MISSION REPORT / RAPPORT DE MISSION

Vat Phou and Associated Ancient Settlements within the Champasak Cultural
Landscape (N481)/Vat Phou et les anciens établissements associés du paysage
culturel de Champassak (République démocratique populaire lao) (N 481)
15-21 February 2012/15-21 février 2012

**Report on the Joint World Heritage Centre/ICOMOS/ICCROM Reactive Monitoring
Mission to Vat Phou and Associated Ancient Settlements within the Champasak
Cultural Landscape (Lao People's Democratic republic)**

Annexe 8: Proposed Landscape Plan

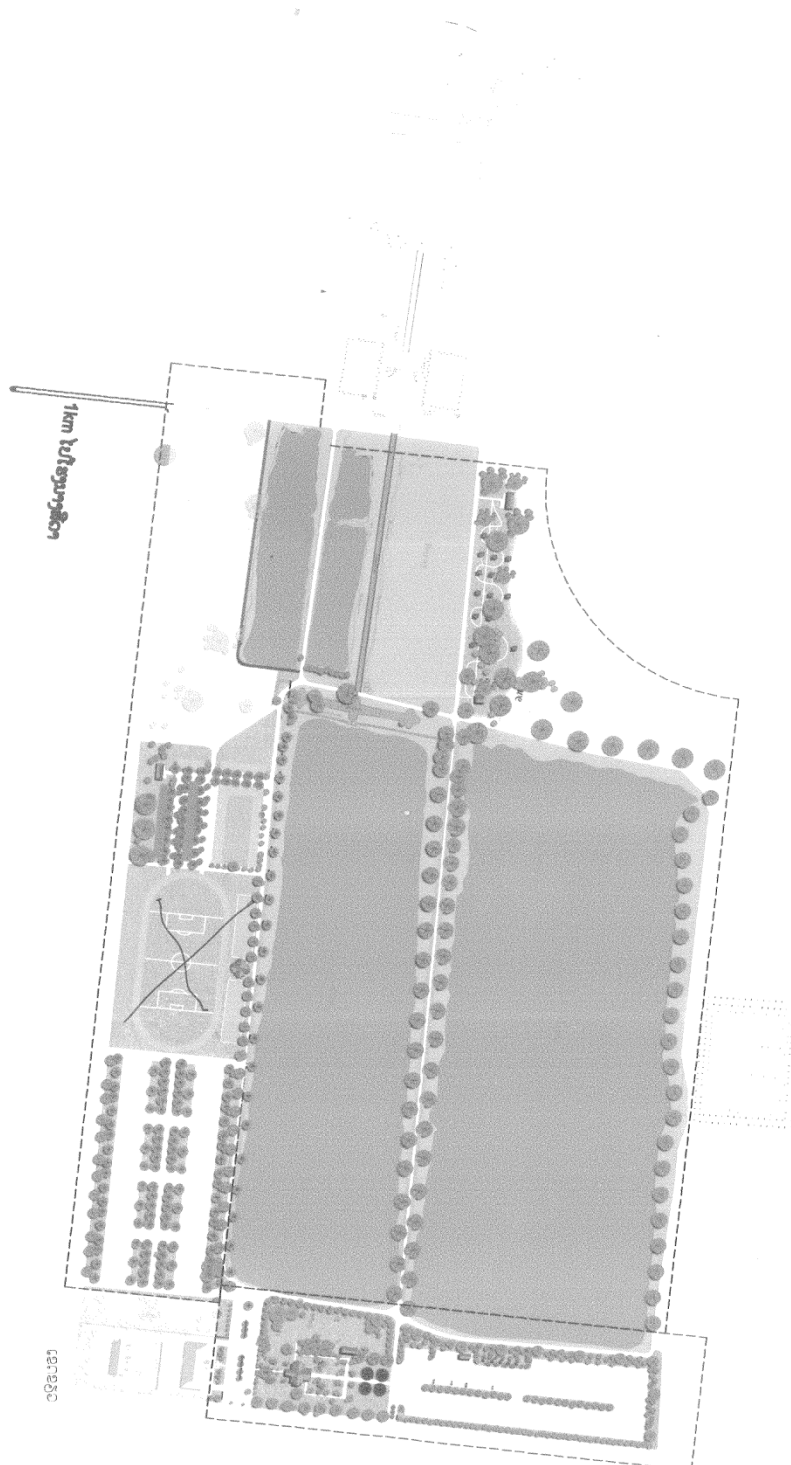
(4) In the longer term as well, there must be a comprehensive landscape plan for Vat Phou - Zone 4 (Monument Management Zone). The current plan, apparently now cancelled, reflects a lack of understanding of the values of the site and the use of inappropriate models. Areas of concern include street lighting fixtures, paving materials, tree planting patterns, etc. As (3), there should be no piecemeal decision-making. Every effort should be made to have a comprehensive plan, which must be approved before implementation by the World Heritage Centre. (See Annexe 8 for the most recent landscape plan, which appears to have been cancelled.)
